Inspector's Daily Report

IDR Sheet	1	of	1	Sheets	Final Record Book	Page
Contract	C-7852			Day	Monday	
				Date	October 25, 2010

Figure 1. A photograph showing the active rockfall location at approximate station 1325+00.

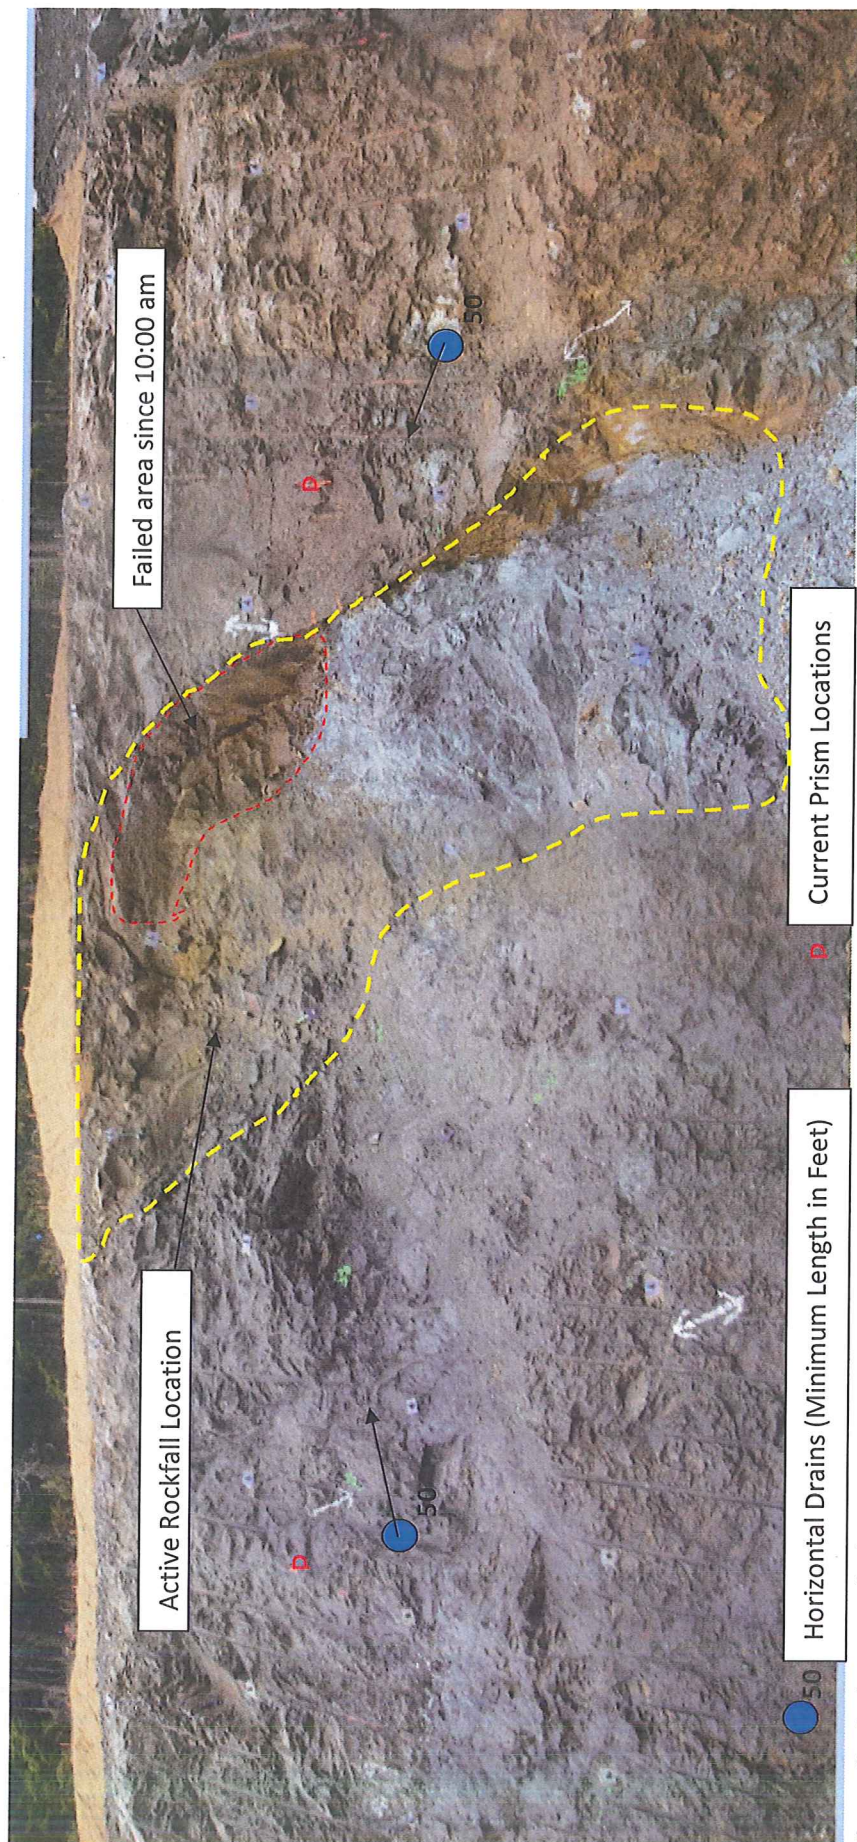
I arrived on the west end of the project to meet Brad Schut (WSDOT Inspector) about a recent rock failure at approximate station 1325+00 (Figure 1). According to Brad, approximately 15 to 20 cubic yards of material failed over the weekend from the same area as the previous couple of weeks. The tension crack that was observed months ago appears to be opening wider where the failure is occurring (Figure 1). The crack appears to be anywhere from 1 to 6 inches wide. According to Norm Norrish, there are prisms located on either side of the failed section with nominal to no measured movement, indicating that this is a localized failure (Figure 2). While I was taking a series of photographs, the slope continued to produce raveling type failures, indicating that the slope is marginally stable in this location.

Figure 2. A photograph showing the recent failure location around station 1325+00. The horizontal drains should be directed towards the active failure location. Note that the prisms on either side of the recent failure location show nominal to no movement.

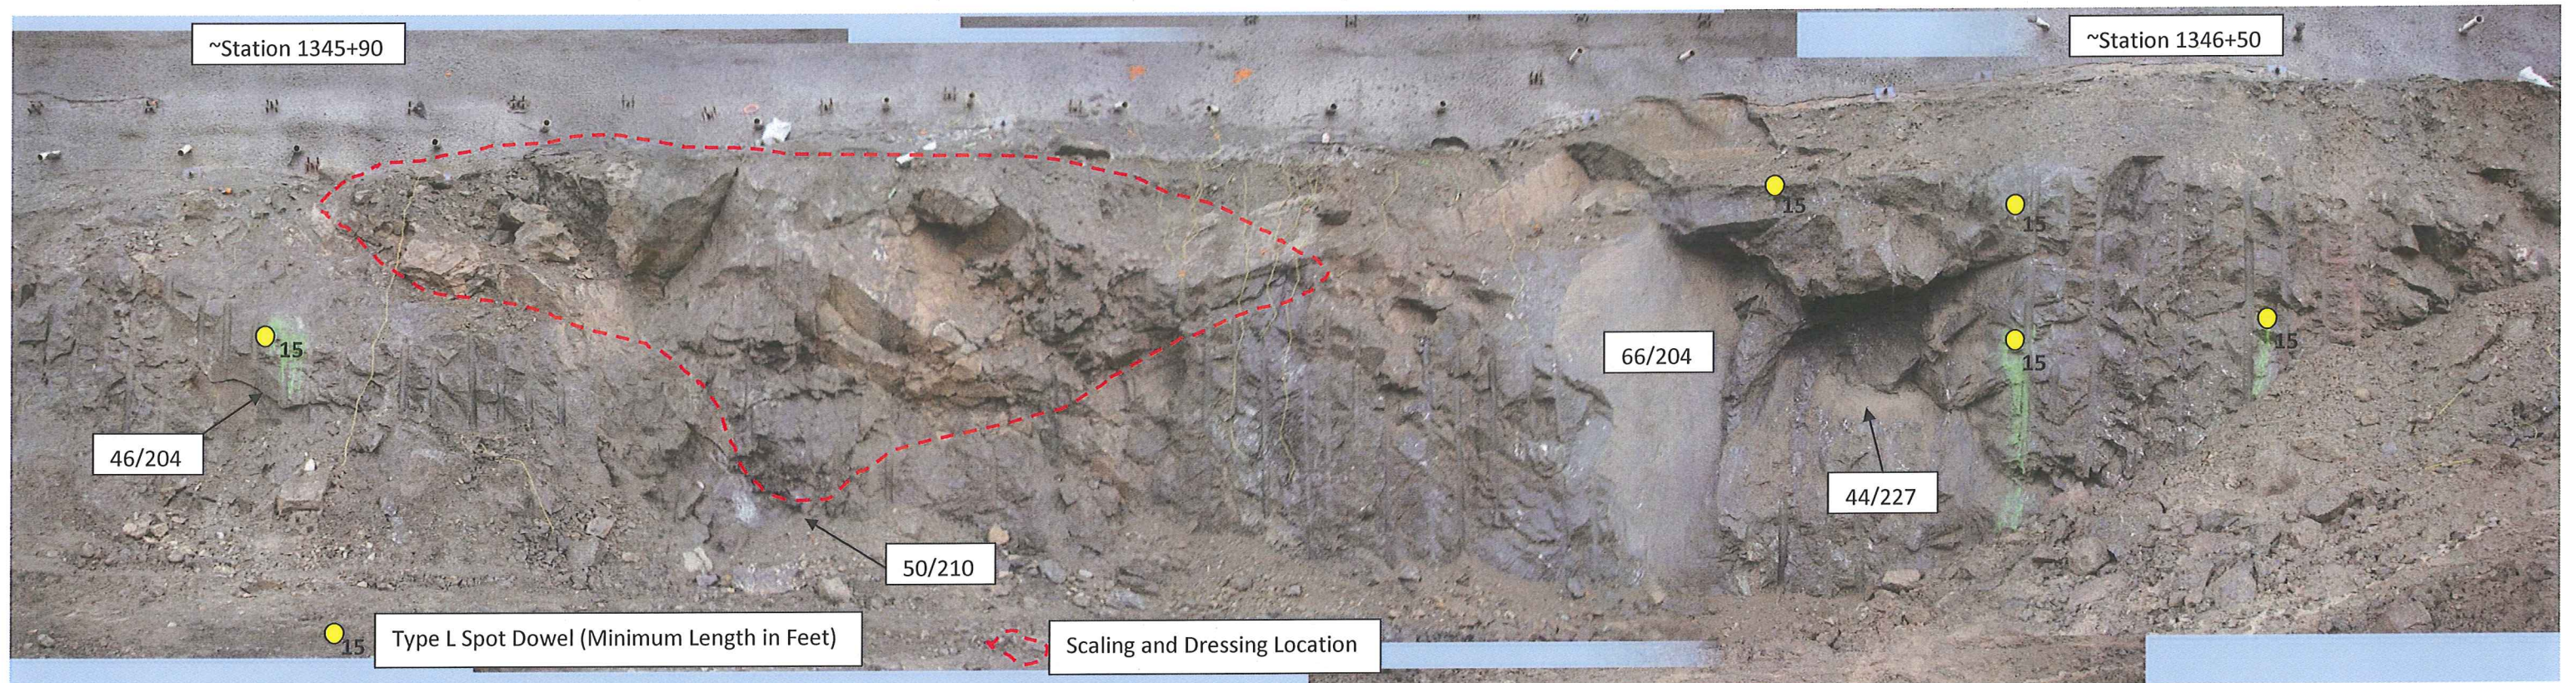
I drove to the Hyak office to download the photographs, send them to the Regional and Geotechnical Division offices, and discuss the slope with Will Smith, Norm Norrish and Tom Badger. I indicated that the slope appeared to be marginally stable and the raveling failures continue. We all came to the decision that it is too dangerous to have the contractor install the shotcrete application at this time and work should focus on the other areas detailed in Mike Mulhern's 8/31/2010 IDR and Norm Norrish's construction memorandum dated 9/27/2010. Norm also indicated that he would like the contractor to install two horizontal drains on either side of the failing area and direct them towards the failed location in an attempt to reduce any water pressure that may be present. These drains should be installed in the more competent bedrock, outside the failed location, as shown in Figure 2.
